07 July 2022

SSD-19989744: SCEGGS Darlinghurst - Adaptive re-use of Wilkinson House

Fig. 1: Demolition Plans of ground, first, second and roof plans of Wilkinson House showing the complete and total demolition of all elements of the original building except for parts of the brick façade. (Source: Smart Design Studio)

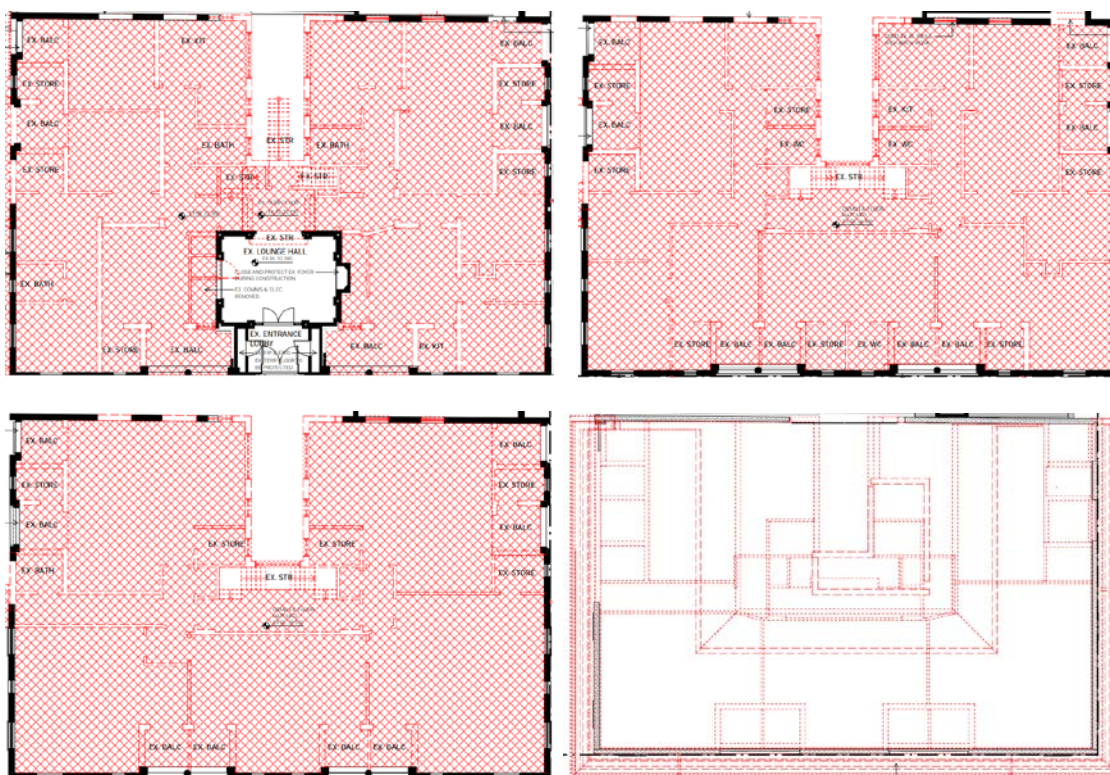
- the demolition of all internal fabric (excluding the small entrance hall at ground level);
- removal of 22 balconies and their infilling with new windows;
- the insertion of nine large new openings in the west elevation;
- infilling of six original windows;
- demolition and widening of the original lightwell;
- the demolition of the entire roof.

In the opinion of the National Trust however, this proposal is not for the “adaptive re-use” of Wilkinson House. It is for retention of the façade only.

We would argue that for this project to genuinely meet the agreed community perceptions of adaptive re-use, a far more inventive proposal is required which retains and responds to the existing fabric and plan of the Wilkinson House building.
